## **Access Compliance Report Public Rights-of-Way** (Curb Ramps)

Intersection ID: 27906 Main Street: BALLANTYNE COUNTRY CLUBrobs Street: HARRISON'S CROSSING AV Location: NE

**ADA ID: C65AEDDAF8C4** Ramp Type: PerpDiag Initial Pass/Fail: Fail **Overall Compliance: No** Severity Score: 13.75

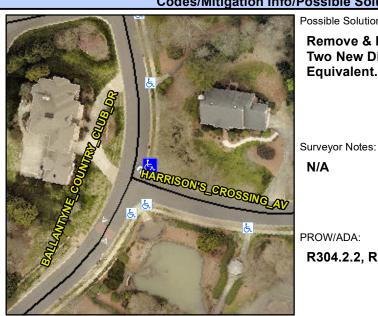
94.0 No

79.0 No

Ramp Slope (%)

Ramp XSlope (%)

Possible Solutions: Remove & Replace Curb Ramp With Two New Directional Ramps or Equivalent.

R304.2.2, R304.5.3
